MINERALS PROGRAM INSPECTION REPORT

MINE NAME: Parkdale Quarry	MINE/PROSPECTING ID#: M-1997-054	MINERAL: Sandstone (silica, stone quartzite), gravel and granite, granite gneiss	COUNTY: Fremont
INSPECTION TYPE: Preoperation Inspection	INSPECTOR(S): Timothy Cazier, P.E.	INSP. DATE: August 9, 2021	INSP. TIME: 11:15
OPERATOR: Front Range Aggregates, LLC	OPERATOR REPRESENTATIVE: Dave Bieber, Phil Courtney, Josh Esquivel	TYPE OF OPERATION: 112c - Construction Regular Operation	
REASON FOR INSPECTION: Surety Related	BOND CALCULATION TYPE: Partial Bond	BOND AMOUNT: \$1,174,724.00	
DATE OF COMPLAINT: NA	POST INSP. CONTACTS: None	JOINT INSP. AGENCY: None	
WEATHER: Clear	INSPECTOR'S SIGNATURE: 	SIGNATURE DATE: October 26, 2021

Image 8. Low water crossing segments requiring inclusion in affected area boundary (outlined by yellow dashed line). {red dotted line outlines unaffected area included in affected area boundary}

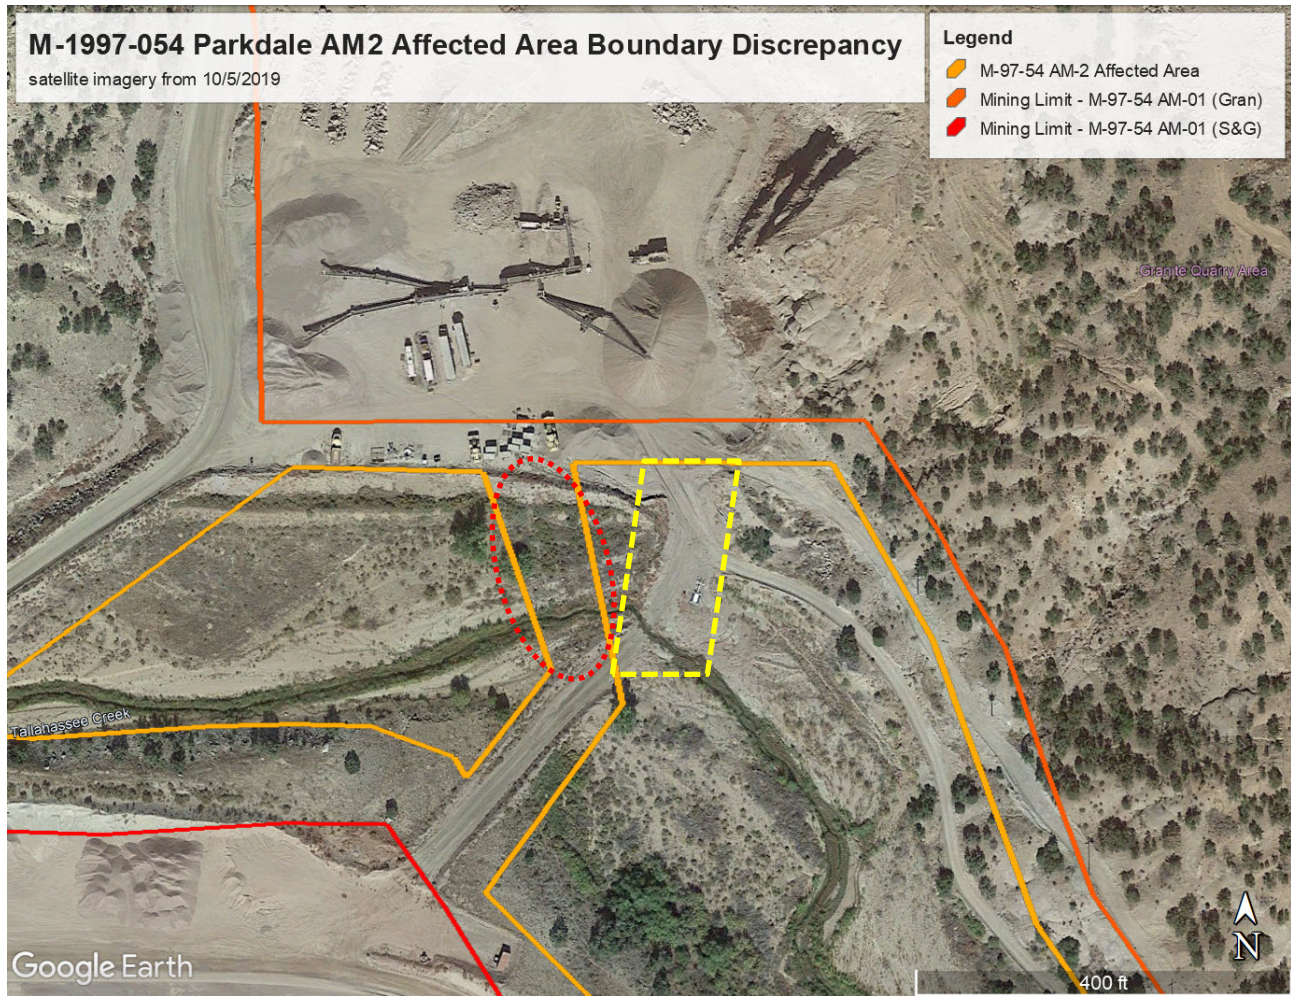
Affected Area Boundary Discrepancy: There are two access roads to the existing Granite Quarry: one over a bridge crossing Tallahassee Creek; the other is a low water crossing through Tallahassee Creek (see **Image 7**). Based on mapping from Amendment 1 (AM1), and carried over to AM2, the segment north of Tallahassee Creek and the segment immediately south of the Creek does not appear to be constructed where perhaps intended in AM1 (see **Image 8**). [Current AM2 maps \(Exhibit C6, D1 through D7, and F\) will need to be revised to show the entire length of the low water crossing is affected area.](#)
